SUBJECT: Provides individual plant exam responses to NRC questions.

Donald C. Cook Nuclear Plant Units 1 and 2  
Docket Nos. 50-315 and 50-316  
License Nos. DPR-58 and DPR-74  
INDIVIDUAL PLANT EXAMINATION  
RESPONSE TO NRC QUESTIONS

STEP 1 IPE REVIEW QUESTIONS OF D.C. COOK IPE SUBMITTALFRONT-END (CORE MELT ANALYSES) QUESTIONS

Figure 3-1

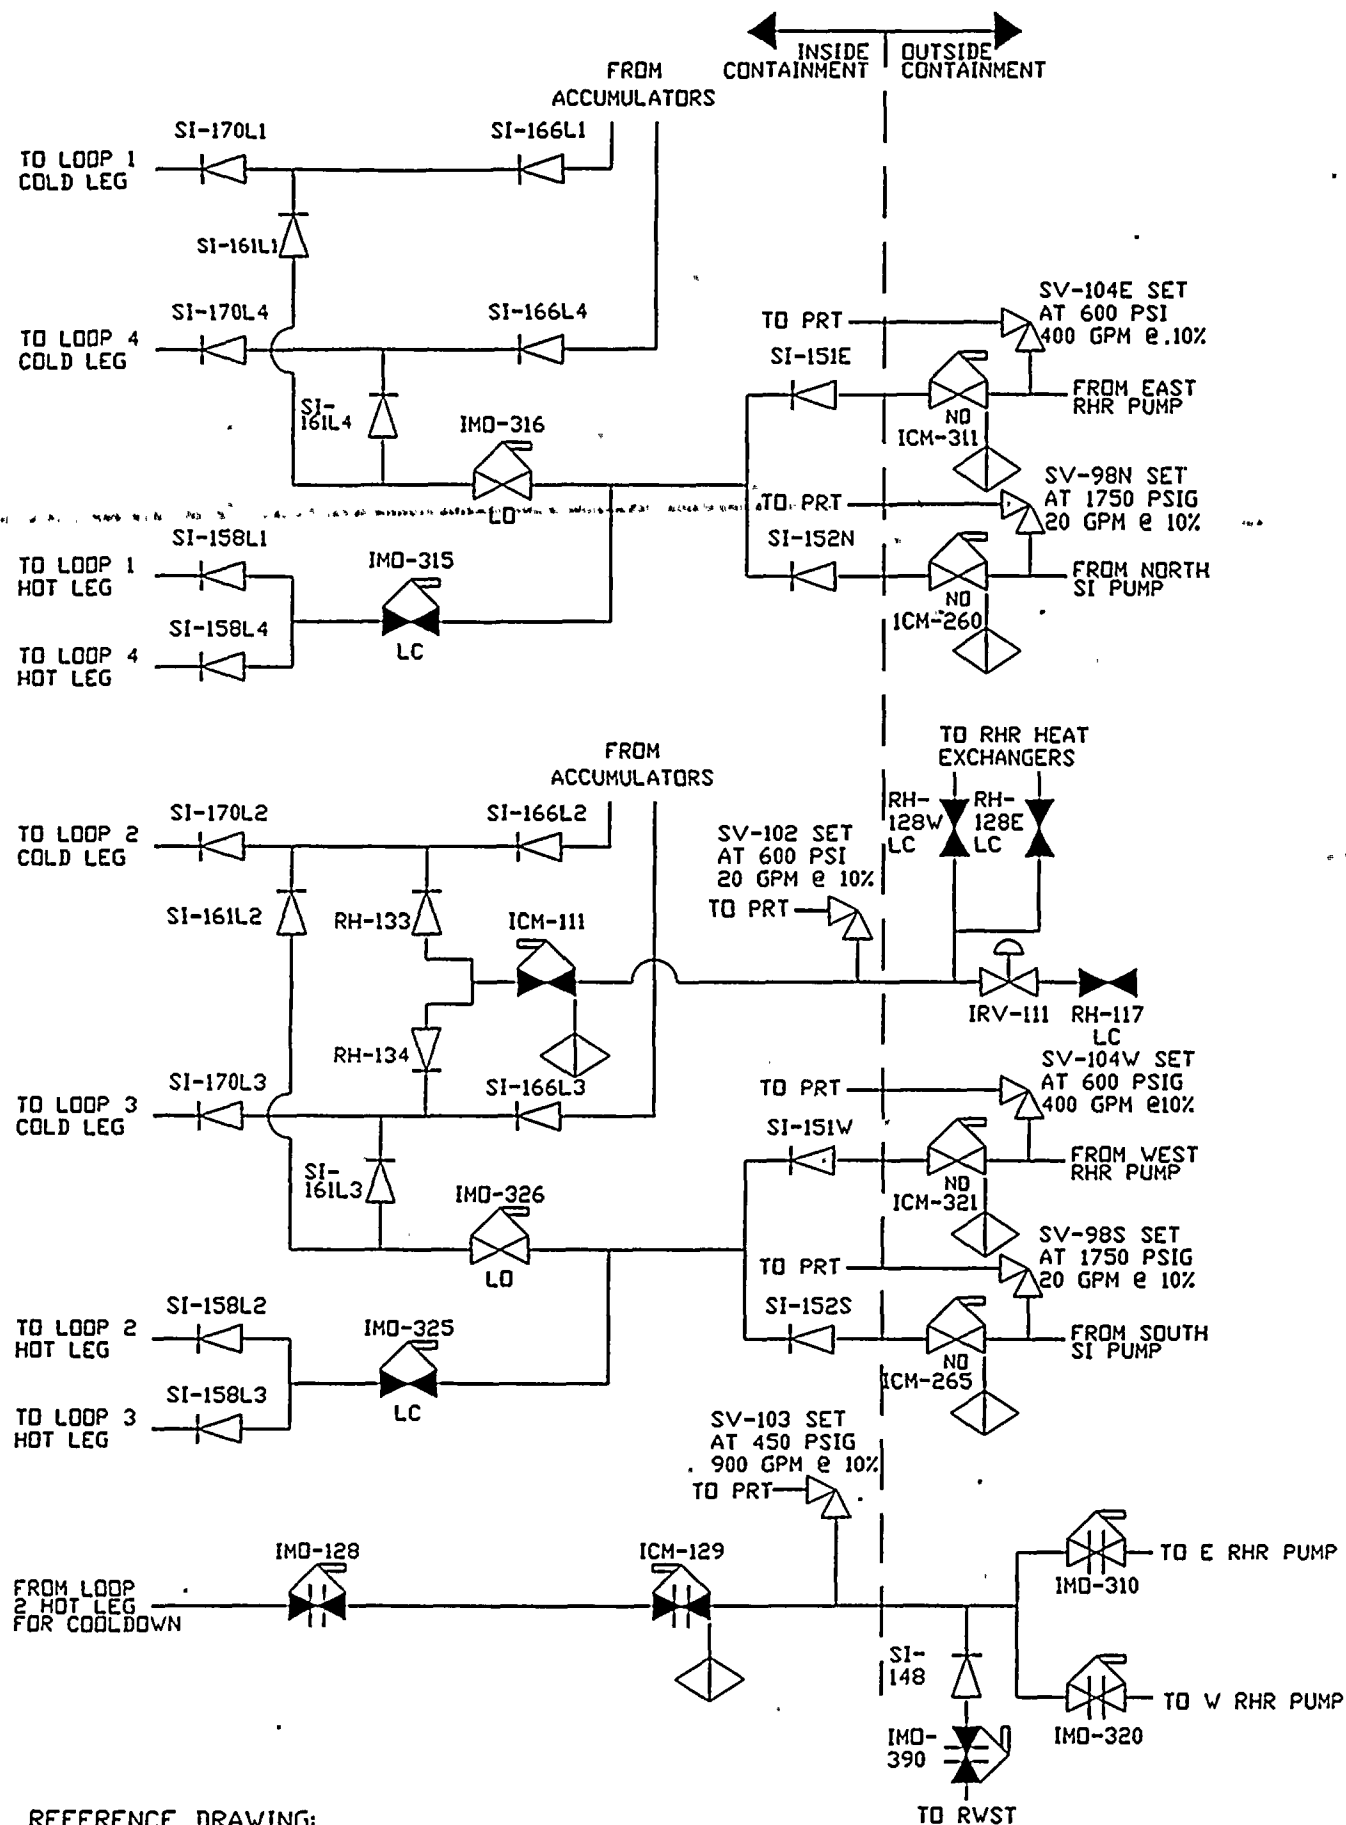
3. NUREG-1335 requests that separate event trees, which may be needed to support special event analysis, be included in the IPE submittal. Although an ISLOCA event tree was provided in your IPE submittal, the documentation is insufficient to determine the process used to determine the initiating frequency and associated mitigating actions. Provide a discussion (with simplified diagrams) of specific systems and components and their associated failure modes modeled for the ISLOCA initiator. Include, for example, the configuration of residual heat removal system, check valves, motor operated valves, surveillance methods and frequency, independence of redundant systems, treatment of human errors associated with valve status, ability to isolate breaks and any administrative controls on MOVs. Also note the verification of design rating of low pressure piping and components, and the potential for loss of critical mitigating systems due to flooding.

Figure 3-1 (attached) shows the potential ISLOCA flow paths which remained from the above screening process. The flow paths are summarized as:

Further assumptions were then made to quantify the frequency of an ISLOCA through each of the above paths shown on Figure 3-1.

Technical Specification (T/S) 4.4.6.2.2 requires that check valves SI-170L2, SI-170L3, RH-133 and RH-134 be tested for leakage after each refueling outage, whenever the plant has been in cold shutdown for 72 hours or more if leakage testing has not been performed in the previous 9 months, and prior to returning the valve to service following maintenance and repair activities.

Additionally, it was noted that the potential for an ISLOCA flow path past check valves SI-170L2 and SI-170L3 was found to be insignificant. These check valves are addressed within T/S 4.4.6.2.2 along with RH-133 and RH-134 (also shown on Figure 3-1). Adherence to this T/S requirement has been restrictive in the past and, in view of this evaluation, removal of this requirement appears warranted.

For the ISLOCA event, losing RCS coolant through the RHR cooldown suction valves is the most probable coolant loss pathway (see Figure 3-1, attached). Sealing this pathway, which is modeled, involves shutting the RHR pump suction valves, thus removing the RHR pumps from further service. This eliminates PBF, since PBF ultimately leads to high pressure recirculation, for which RHR pumps are required. Thus, PBF as a long term cooling medium (in this case) with refilling the RWST would be more difficult since containment pressure increases must now be addressed. First, the auxiliary feedwater system is the normal source of removing decay heat and is modeled as such in the ISLOCA event tree. Second, per the IPE submittal, not only was the ISLOCA initiating event frequency low ( $1.0\text{E-}07$  range), but ISLOCA was the least contributing event to overall core damage frequency. Thus, further investigation of this event did not appear to be warranted.
